UNITED STATES PATENT AND TRADEMARK OFFICE
CERTIFICATE OF CORRECTION

PATENT NO. : 6,919,880 B2
APPLICATION NO. : 09/870698
DATED : July 19, 2005
INVENTOR(S) : Gerald Morrison and David Holmgren

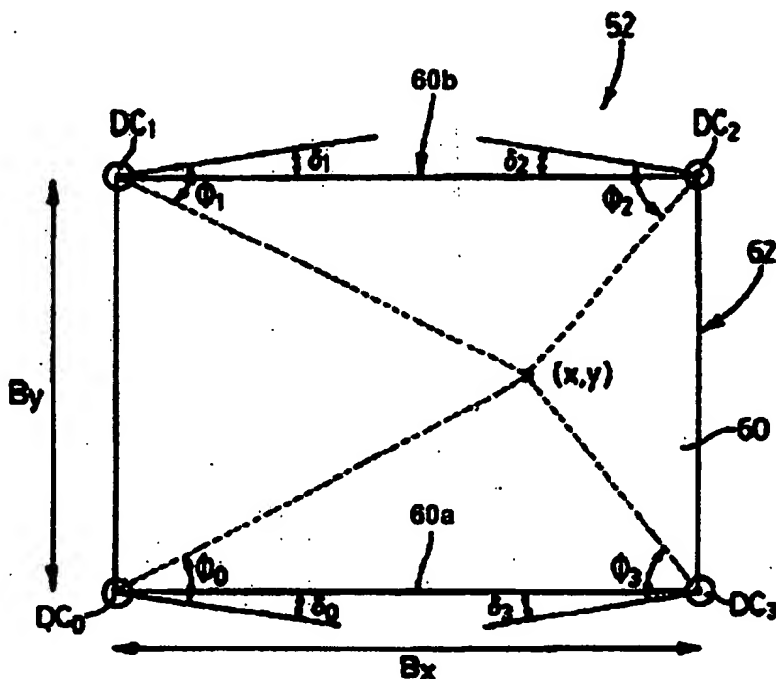
On the Cover Page, in the Representative Drawing, “62 a” should read --60a--.

On the Cover Page, in the Representative Drawing, “62 b” should read --60b--.

FIG. 2

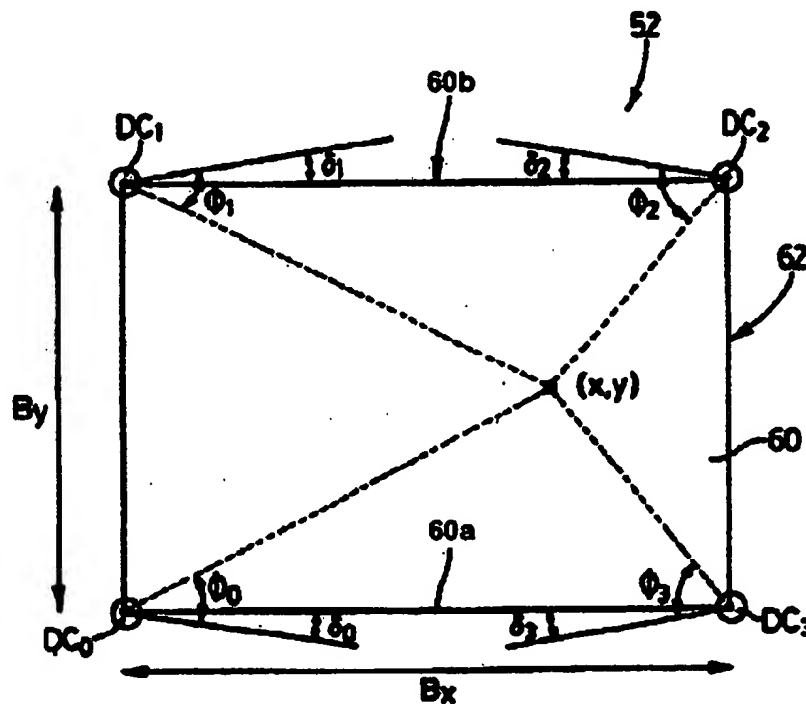
In the Drawings, Figure 2, "62a" should read --60a--.
In the Drawings, Figure 2, "62b" should read --60b--.
